DUKE COGEMA
STONE & WEBSTER

8 March 2002
DCS-NRC-000085

Subject: Docket Number 070-03098
Duke Cogema Stone & Webster
Mixed Oxide Fuel Fabrication Facility
Construction Authorization Request
Clarification of Responses to NRC Request for Additional Information

Enclosures: A. Responses to NRC Clarification Requests
B. Natural Phenomena for MFFF Design

Figure I: Seismic Hazard Curves for Horizontal Design Response Spectrum.

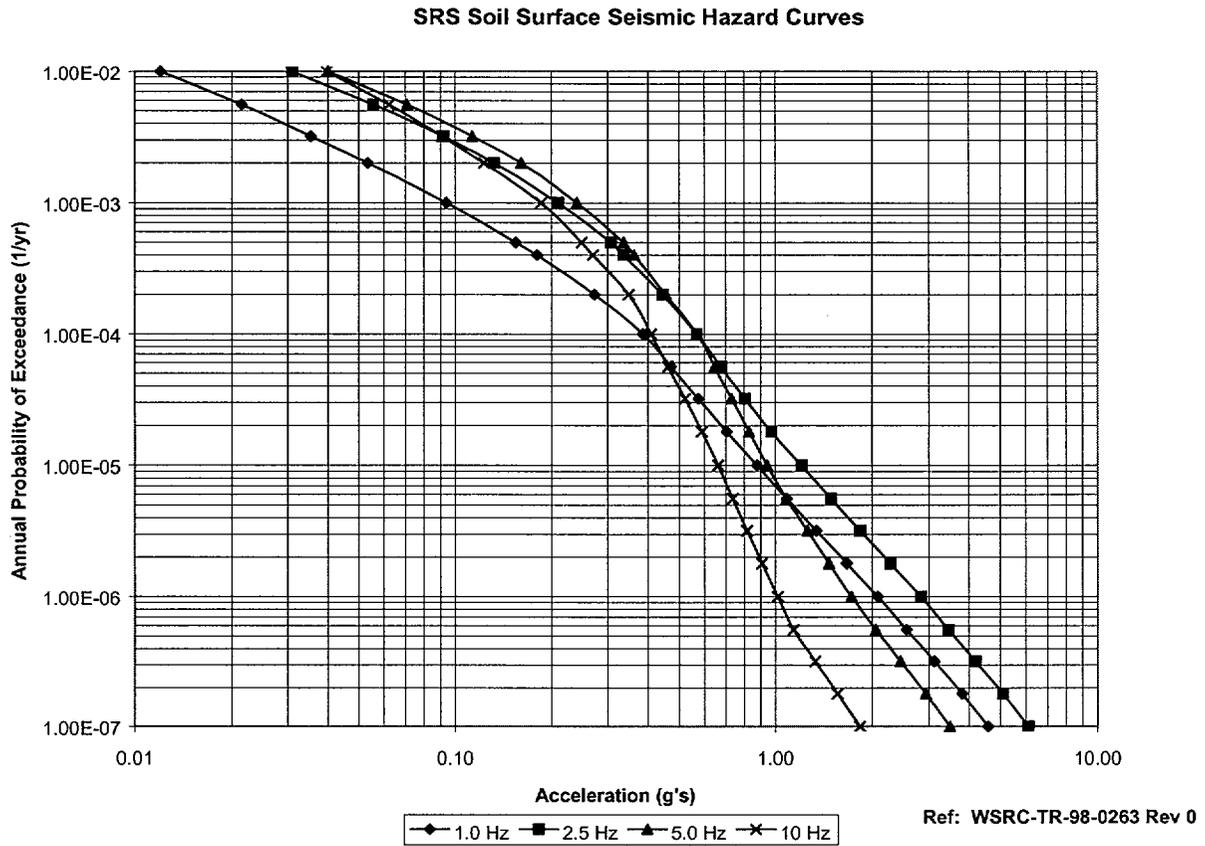
CAR Figure 1.3.6-16 presents soil surface hazard curves for SRS, expressed in terms of spectral velocity (S_v) versus annual probability of exceedance. As discussed in CAR RAI-021, the figure

can be converted to an acceleration hazard curve by the relationship $S_a = 2\pi f S_v$, and appropriate conversion factors to convert accelerations to “g’s.” WSRC-TR-98-00263, Rev. 0, “Soil Surface Seismic Hazard and Design Basis Guidelines for Performance Category 1 & 2 SRS Facilities,” by R.C. Lee, September 1998, is the source document for WSRC-TR-2000-00454. Figures 6.9 and 6.10 of WSRC-TR-98-00263 present the velocity and acceleration hazard curves. The site soil surface acceleration hazard curve is reproduced in Figure I.

Figure III. Comparison of MFFF Horizontal DE Response Spectrum to Soil Surface UHS at Four Spectral Frequencies

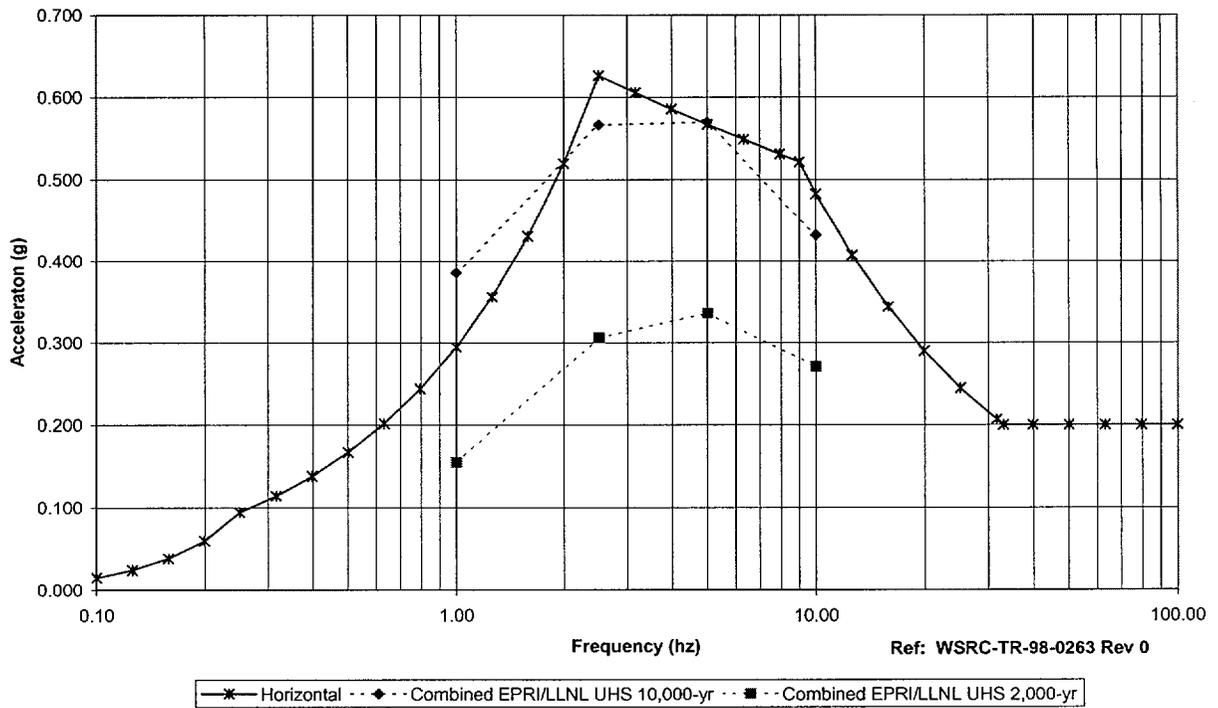
In these calculations, DBE is the design earthquake level at the corresponding frequency being considered. These DBE levels can be taken from the DE curve in Figure III, where the curve intersects with the appropriate frequency value.

Table III shows the calculation of fragility data, which are based on a DE equal to the 0.20g Regulatory Guide 1.60 horizontal response spectrum shown in Figure III. Figure V shows representative fragility relationships for items designed for a 0.2g seismic design basis (DBE).
